STATE HIGHWAY 105 / JACKSON CREEK PARKWAY - PHASE 2

CONSTRUCTION PLANS

Comments provided by DPW Capital Projects

CCES RESPONSES

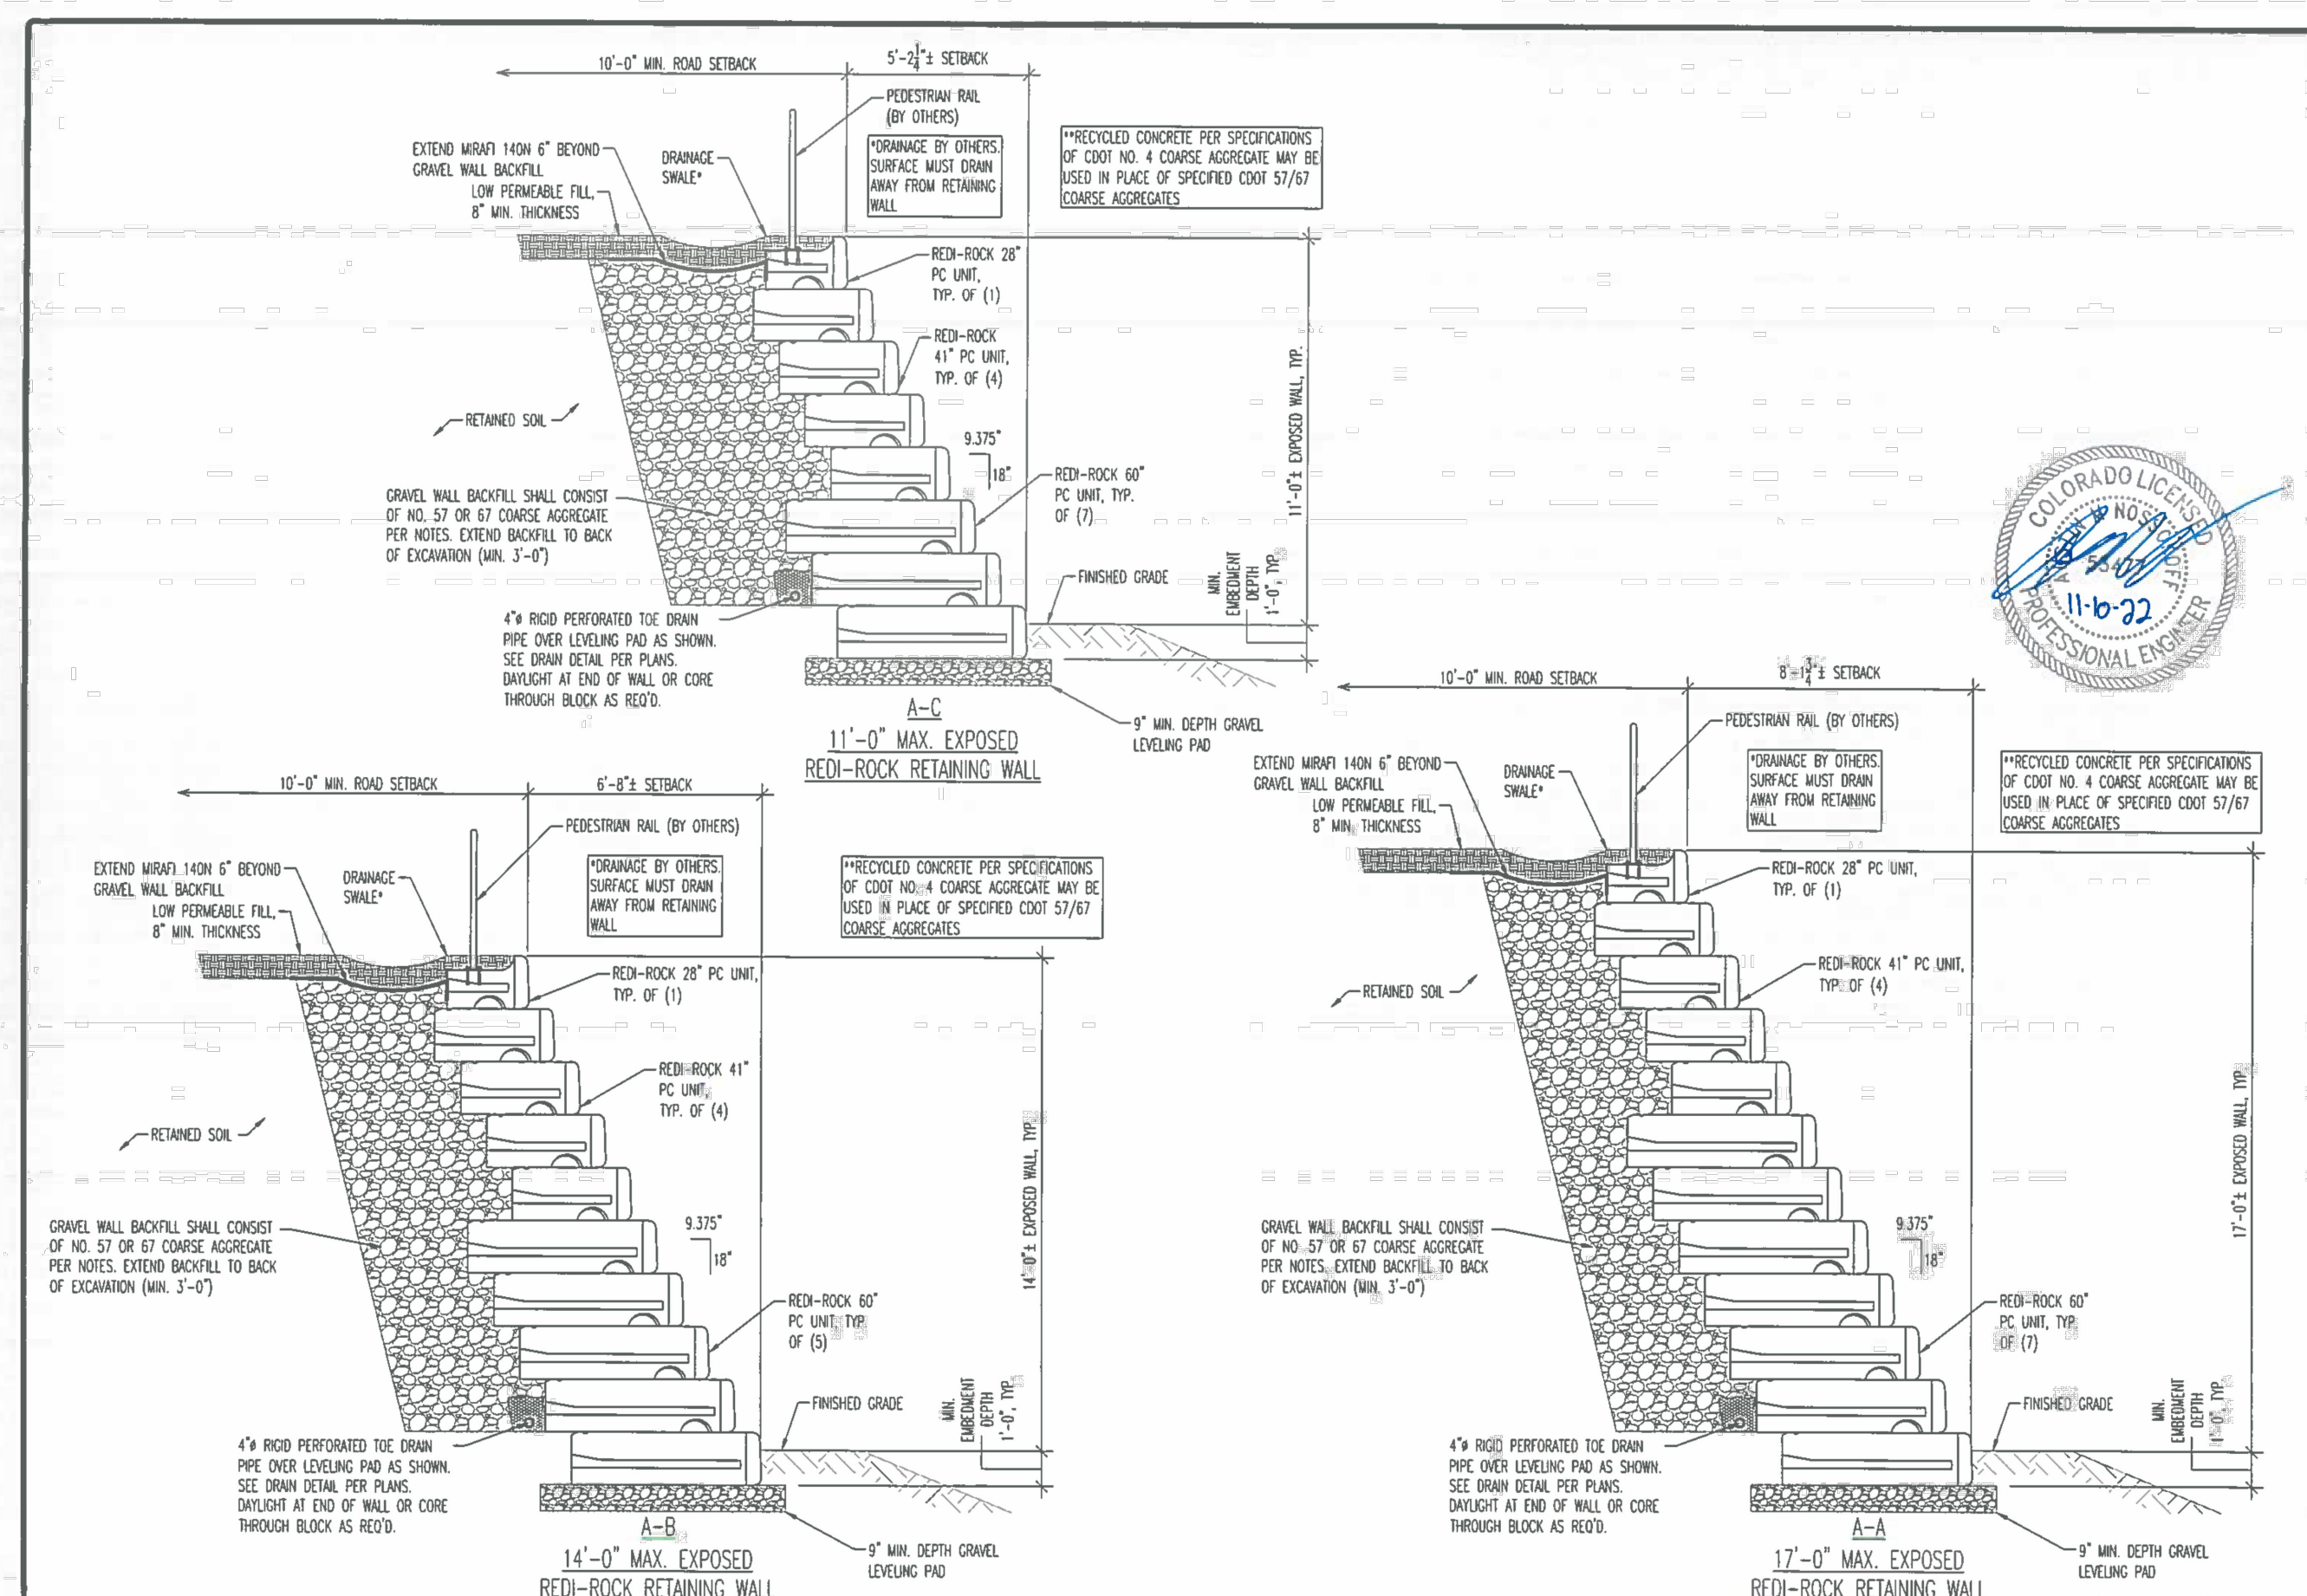
Unresolved: Include calculation in drainage report to show that drainage is sized to adequately handle flow. **NOW ADDED TO REPORT**

TYPICAL HOT MIX ASPHALT PAVEMENT LIFT SECTION

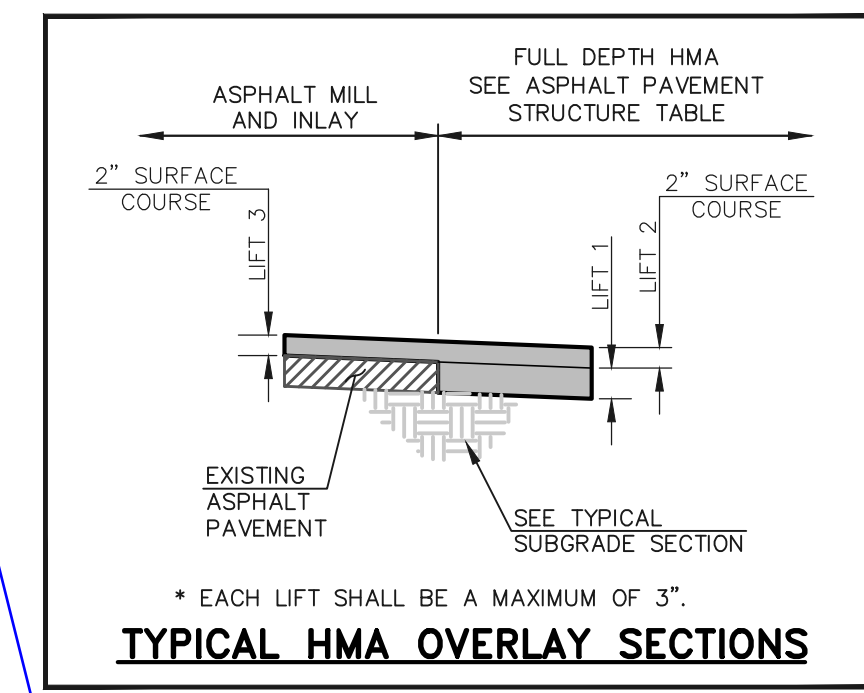
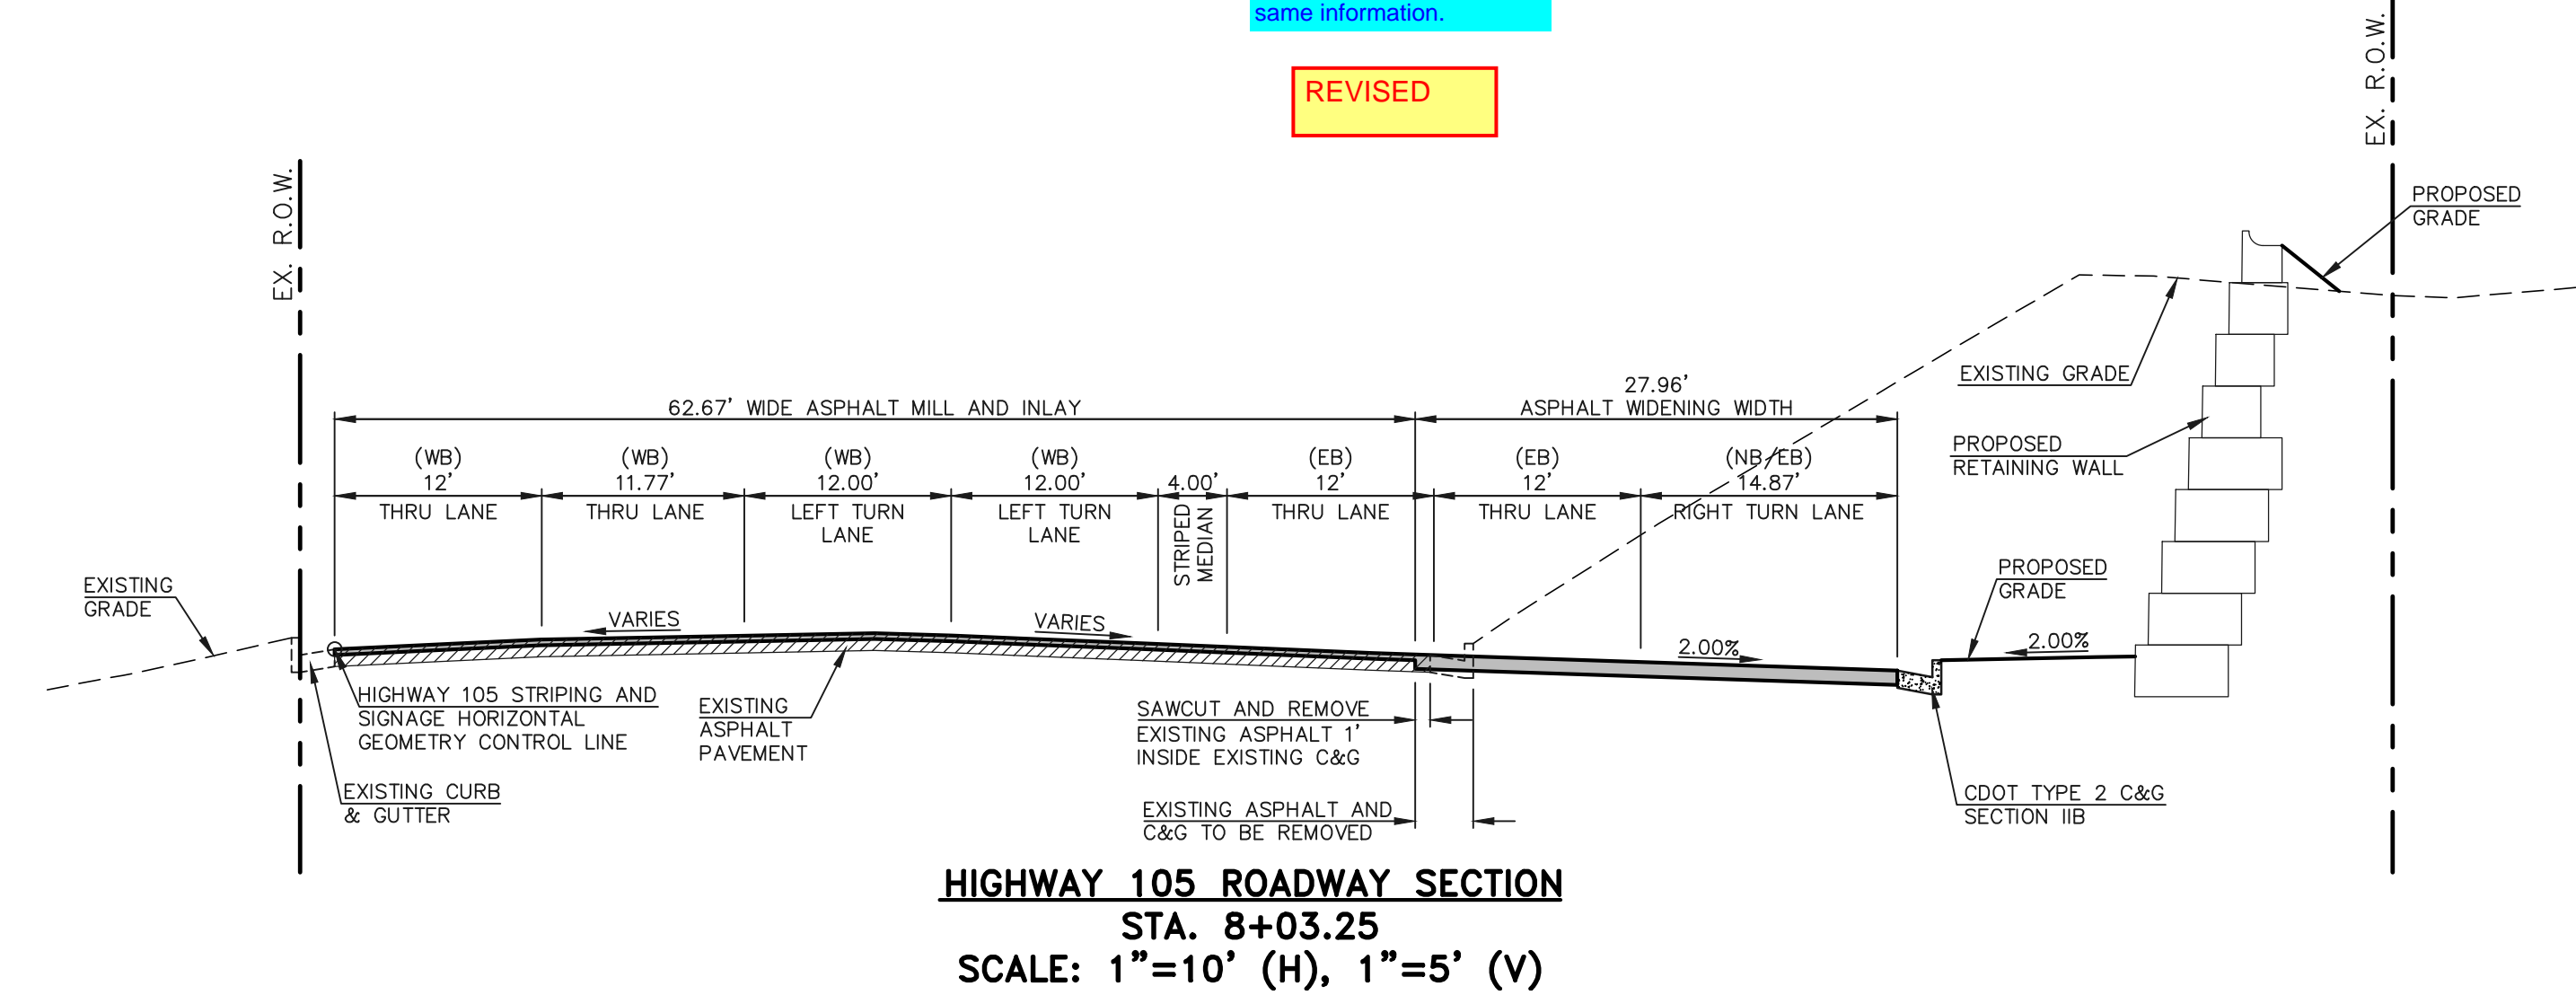
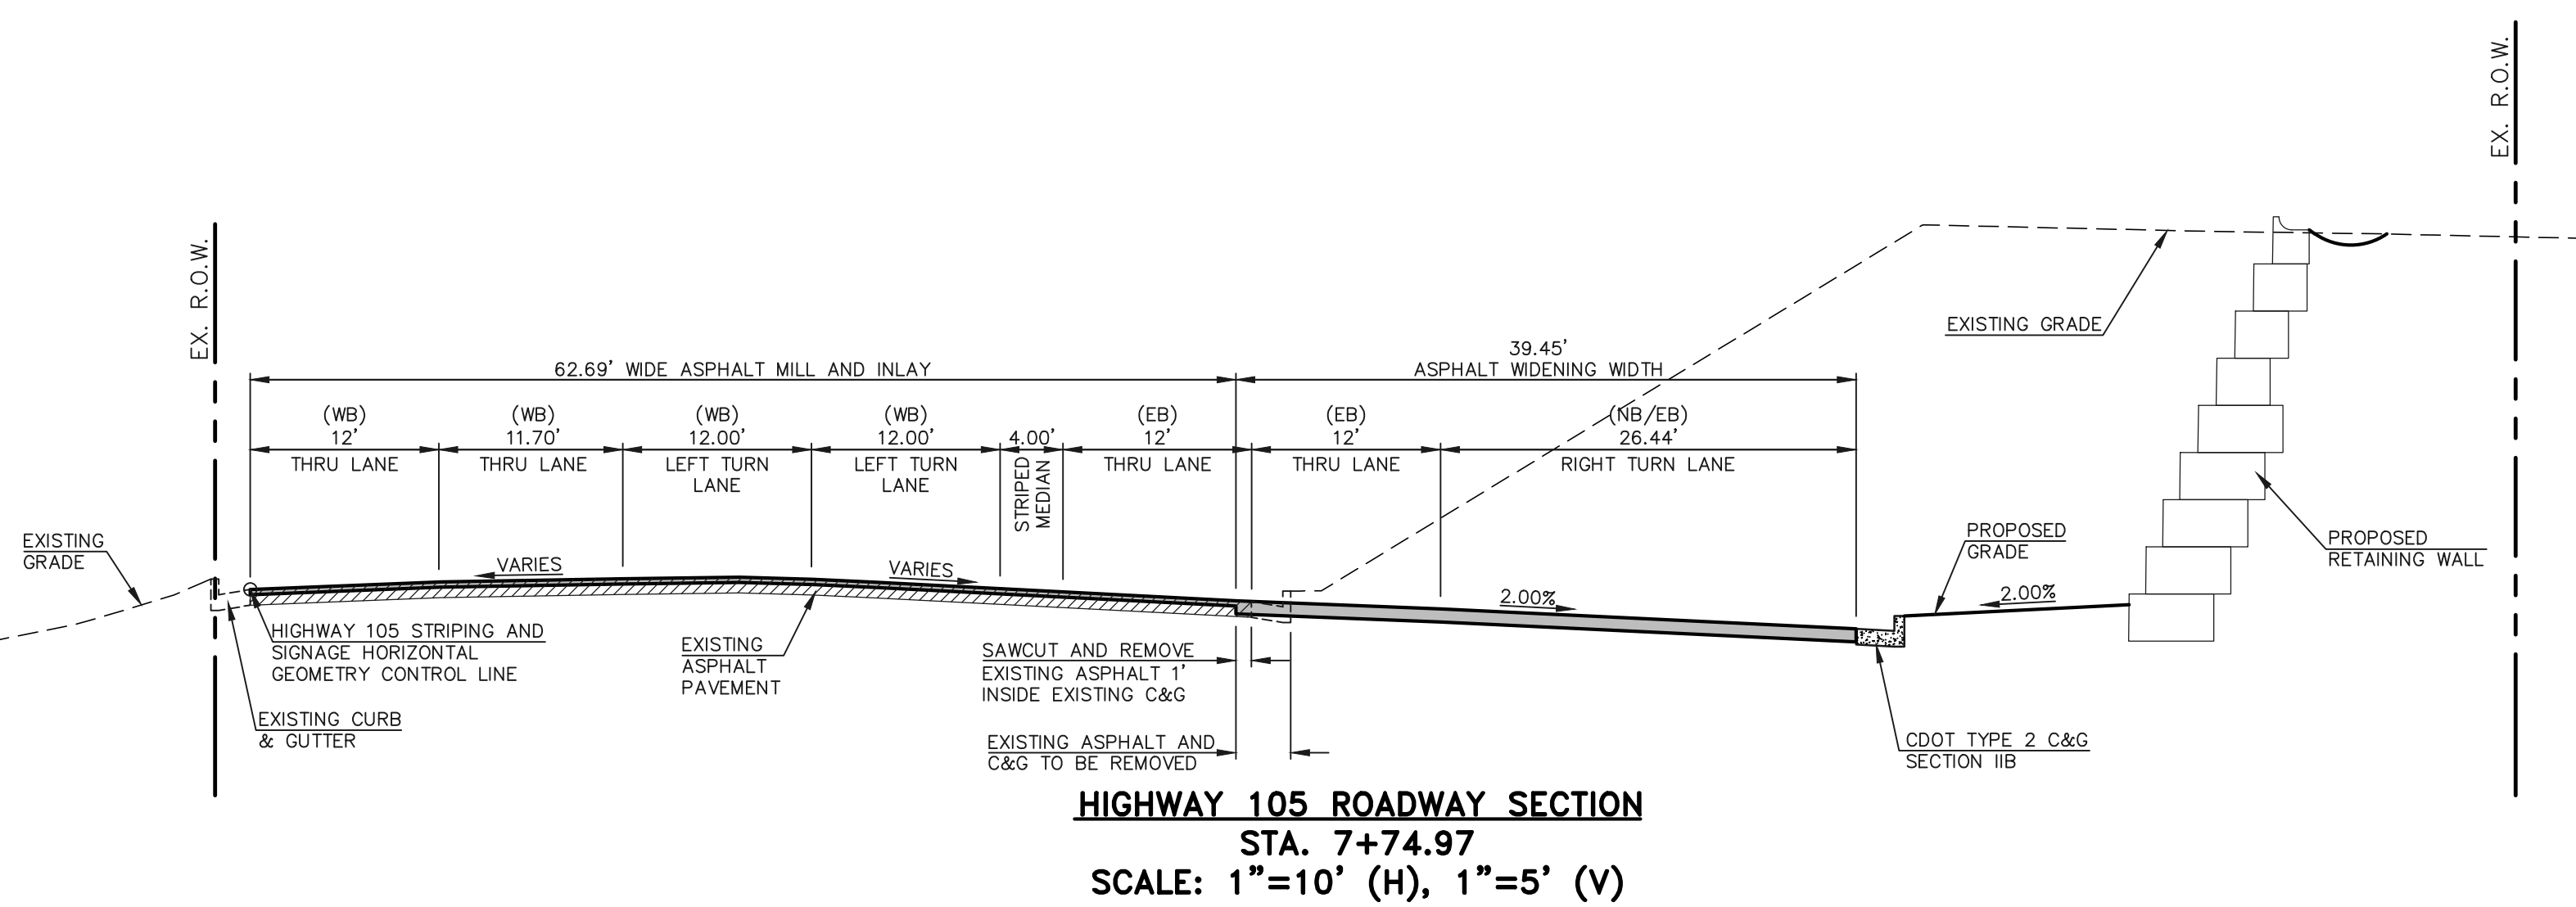
Pavement section detail calls for 6" of asphalt but pavement section lift detail only adds up to 5". Please revise so details show same information.

Pavement section detail calls for 6" of asphalt but pavement section lift detail only adds up to 5". Please revise so details show same information.

REVISED

REVISED

STATE HIGHWAY 105 / JACKSON CREEK PKWY. - PHASE 2 CONSTRUCTION PLANS
 ROADWAY IMPROVEMENT PLANS
 JACKSON CREEK PKWY. ROADWAY SECTIONS

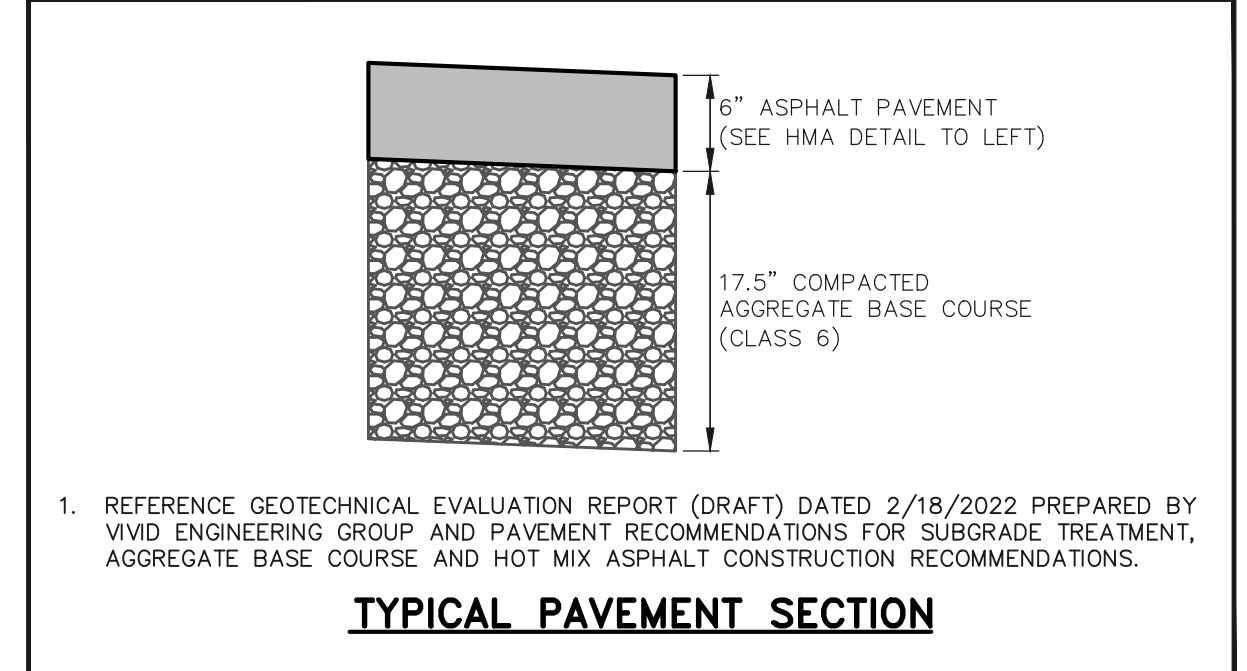
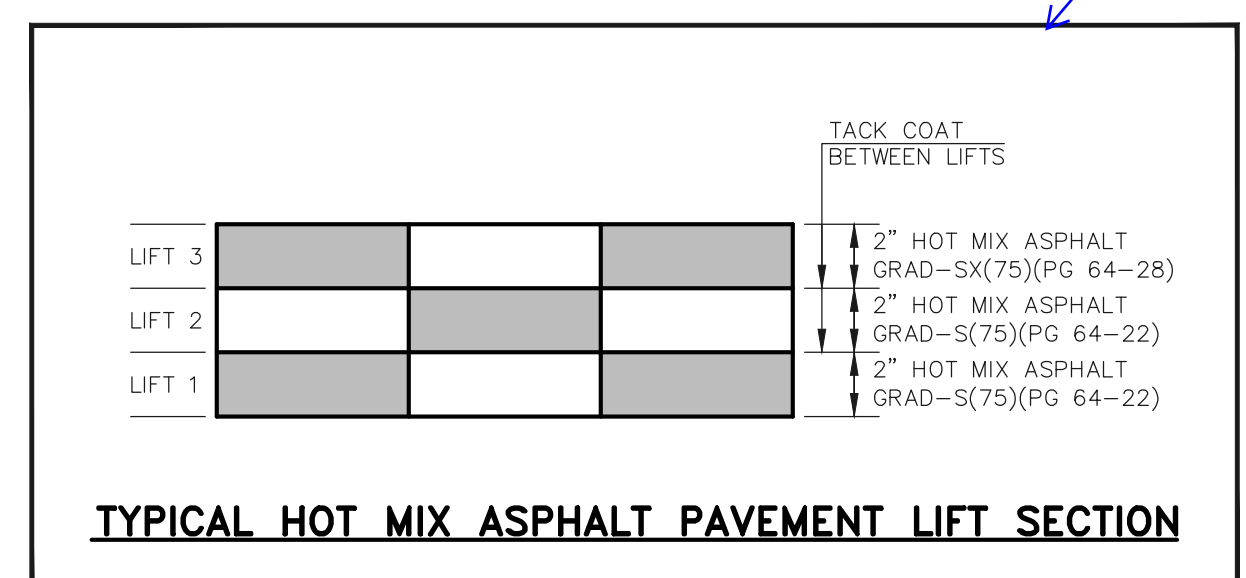
Asphalt lift is different than previous sheets. Please revise to same detail or clearly state where different lift sections are happening within plan.

THERE IS A DIFFERENT PAVEMENT DESIGN FOR JCP VS. HWY. 105. NOTE NOW ADDED TO EXPLAIN.
